SUNDRY NOTICES AND REPORTS ON WELLS
*Do not use this form for proposals to drill or to re-enter an
Abandoned well. Use Form 3160-3 (APD) for such proposals.*

Florance Gas Com L

BP AMERICA PRODUCTION COMPANY

Other Chng To Coil Tbg
Unit & BOP Chng

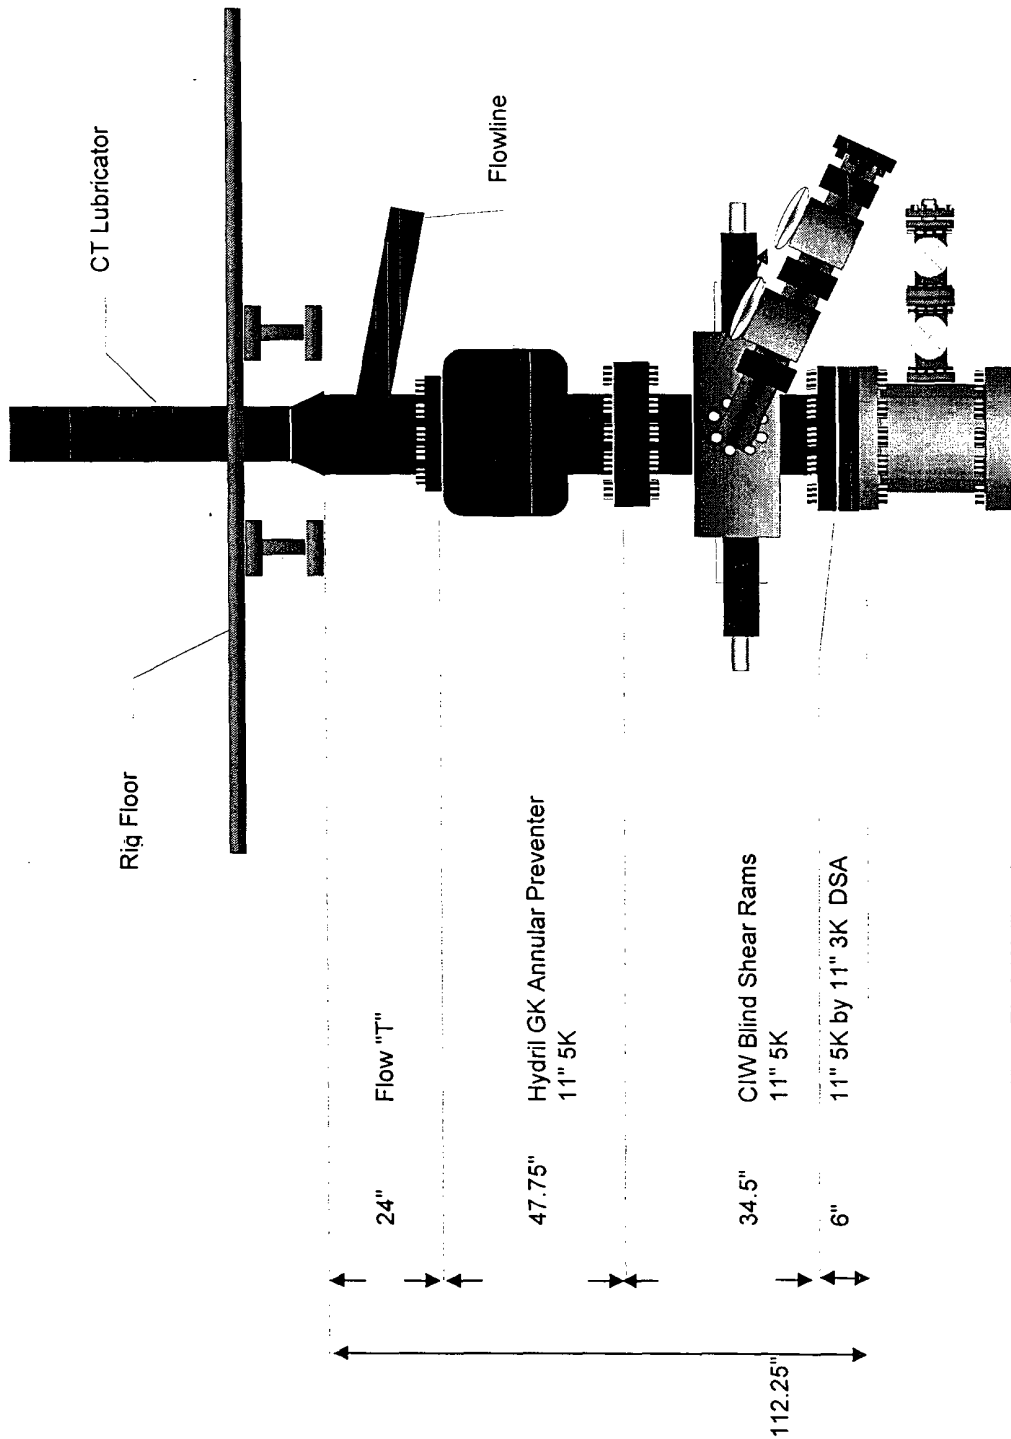
The CTD Unit has a slightly different BOP configuration from our conventional drilling rigs. Instead of the 11" x 3,000 psi blind ram & annular configuration; the CTD is equipped with an 11" x 5,000 psi blind/shear ram & annular stack. Because we are drilling into the underpressured Coal & PC only, we would like to limit our test pressures to 250 psi / 750 psi. Please see the attached schematic from Knight Oil Tool Rentals.

Verbal approval was granted by the BLM on April 28, 2006 to change BOP due to Coil Tbg Unit.
